PMT2
Power supplies

1 News

2 Product update

2.7 UPDATE – AS02LC-A firmware updated

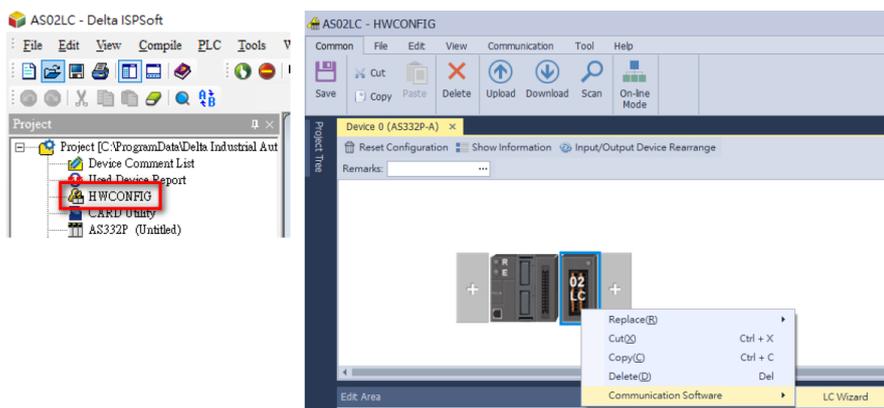
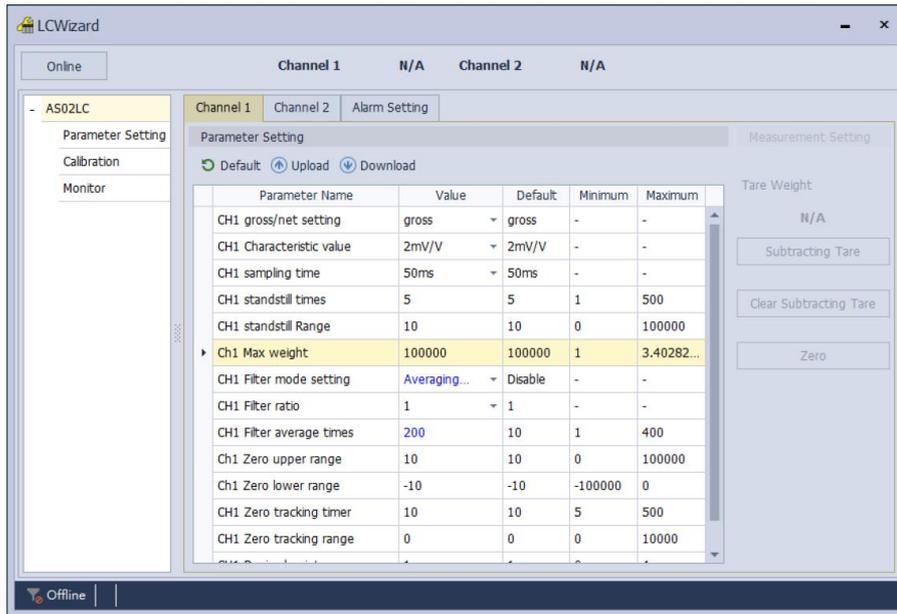
The LC Wizard (ISPSOft V3.10 -> HWCONFIG -> AS02LC-A Communication Software -> LC Wizard) is a calibration software exclusively for AS02LC-A. For easier operation, a new function, on-line mode is added; you can check the current weight value, status flag and other parameters when using this mode.

- The latest LC Wizard is included in ISPSOft V3.10 and later versions.
- For AS02LC-A modules with firmware V1.04 or higher versions, you need to use ISPSOft V3.10 or later versions.

2.8 UPDATE – DPM-D520I: RJ45 port removed

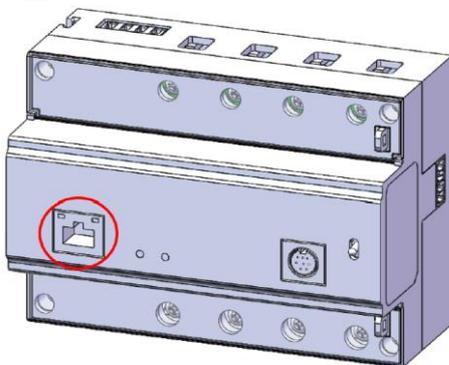
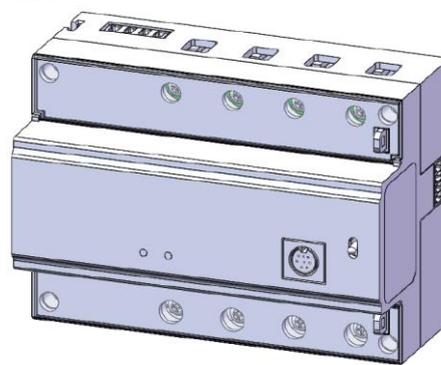
To avoid users mistake the RJ45 port in front of DPM-520I for an Ethernet port, we removed the RJ45 port design in DPM-D520I.

If the date code is 2015 (year 2020, week 15) or later, it means the device is without any RJ45 port.

Restarting wizard flow chart

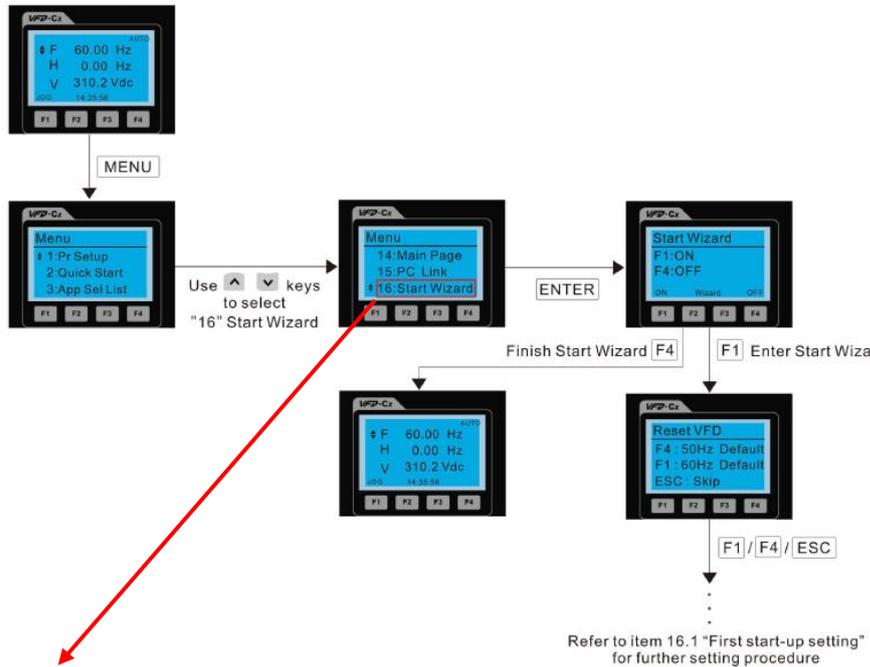
2. Add test mode in start-up setting process

- When the screen presents Figure B and press the MENU key, it will ask "Go to test mode" screen, as shown in Figure C. Selecting "YES" will directly enter the Menu screen, as shown in Figure D. For detailed operation, please refer to "New drive start-up setting Process".
